**ITB 2023-39 Songbird Avenue Intersection Improvements and Floyd Gray Road/Lawhon
Mill Road Paving Project
Addendum No. 1**

**Addendum No. 1 ITB 2023-39
SONGBIRD AVENUE INTERSECTION IMPROVEMENTS AND FLOYD GRAY
ROAD/LAWHON MILL ROAD PAVING PROJECT**

Issued January 17, 2024

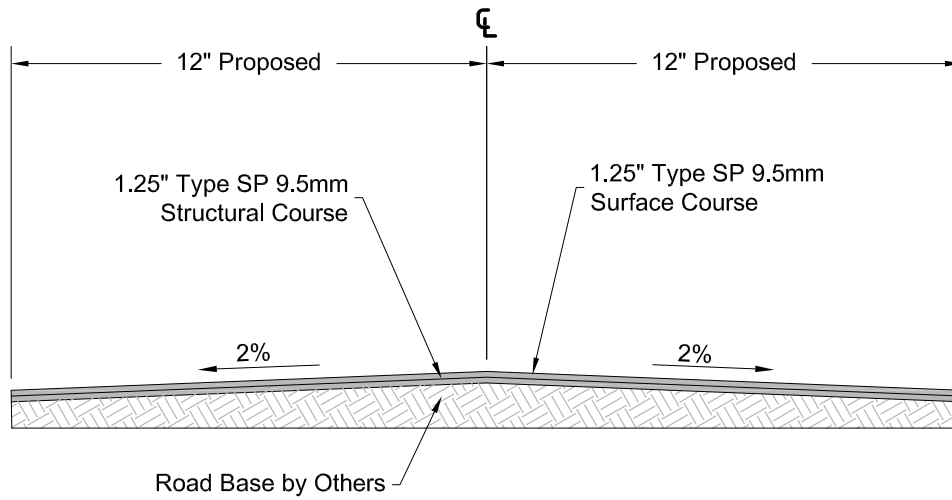
Q3: Regarding Arran Road/Songbird Avenue Roundabout: Is there a color specification/requirement for the concrete pavement at the round about?

A3: Yes. The color shall be AMS-STD-595-21105 RED, as shown on the typical section on sheet 5. The cost of the coloring shall be included in the price of the concrete.

Typical Section - Lawhon Mill Road/Floyd Gray Road

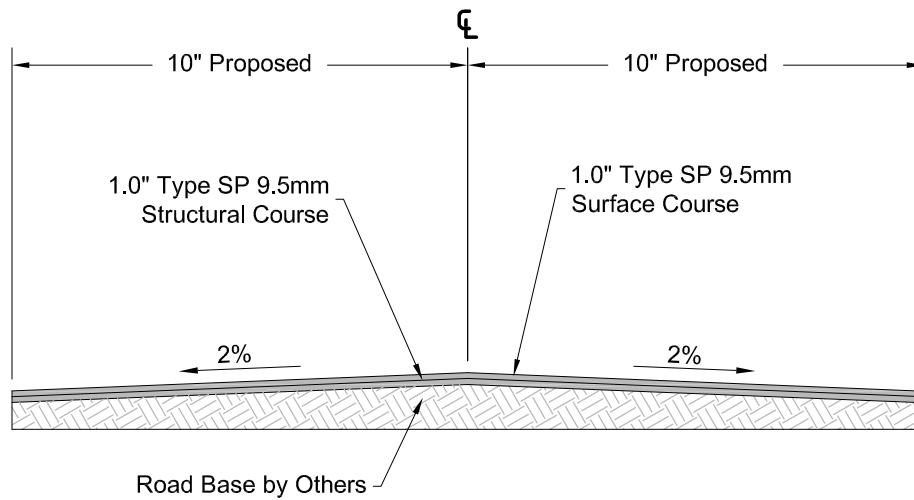
Q4: Regarding Floyd Gray Road/Lawhon Mill Road: Can you please provide a road section for the Floy Gray Rd and Lawhon Mil Rd?

A4: Please see the attached typical sections.

1. County to install and rough grade base material
2. Contractor shall complete final compaction and clipping prior to paving
3. Driveways paved to ROW line
4. No drainage, striping, signage or grassing included in this bid.
